NUMBER: 54

THOMAS SERVICE BULLETIN

SUBJECT: MODEL T-30 TANK RECALL

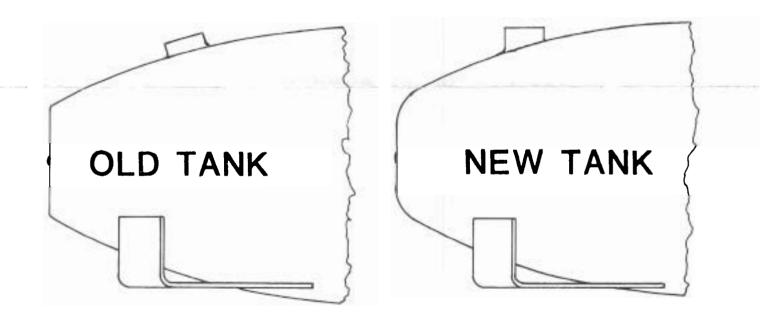
PLEASE OBSERVE THE PHOTOGRAPH OF A MODEL T-30 WITH A RUPTURED TANK. THESE OLD STYLE TANKS ARE DANGEROUS AND THEIR RUPTURE MAY RESULT IN SERIOUS INJURY OR DAMAGE.
